From: [REDACTED]
To: [REDACTED]
Cc: [REDACTED]
Subject: RE: [EXTERNAL] Blacktip P3 Cementing Review - NOPSEMA IVT12244
Date: Monday, 19 June 2023 12:24:45 PM
Attachments: [image001.jpg](#)
[image002.png](#)
[image003.jpg](#)

From: [REDACTED] @nopsema.gov.au>
Sent: Tuesday, 9 May 2023 1:38 PM
To: [REDACTED] @external.eni.com
Cc: [REDACTED] @nopsema.gov.au; [REDACTED] @eni.com; [REDACTED]
[REDACTED] @nopsema.gov.au; [REDACTED] @nopsema.gov.au
Subject: [EXTERNAL] Blacktip P3 Cementing Review - NOPSEMA IVT12244

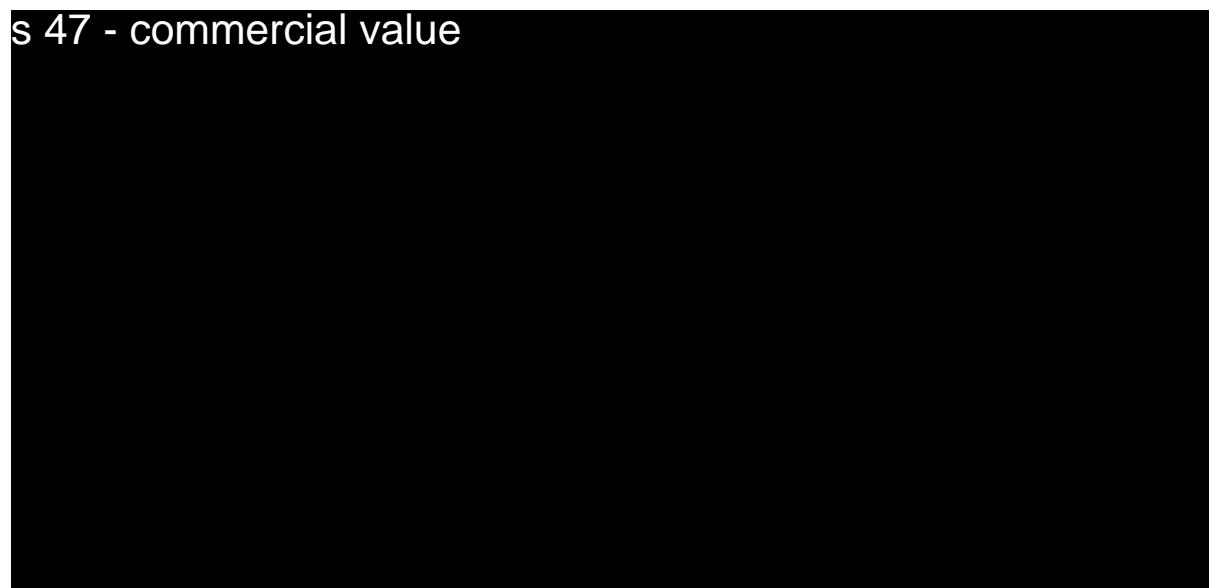
Thanks for the updates. I can see the pinching effect you refer to.

I'm getting periodically confused by the B/C terminology, so I've added in my interpretation below in blue. Please correct me if I'm wrong. I suggest we include pipe sizes (13-5/8 x 20") to avoid confusion.

In earlier emails, you mentioned "*The piping connects A & B "wellhead" annuli outlets together. So, the monitoring screen in the gas plant reads one pressure for the A&B annuli*". Am I correct in assuming this is because there is no B annulus for this well, because of the well architecture (9-5/8" and 7" liners). Could you please confirm that the 13-5/8" x 20" annulus is monitored independently (as it appears). Also, is the 20x30" monitored?

The 13 5/8" x 20" annulus is independently and continuously monitored. From this point on and for clarity, we'll refer to the annuli as 13 5/8" x 20" annulus or production annulus.

The 20" x 30" is not monitored.

Your interpretation below is correct.
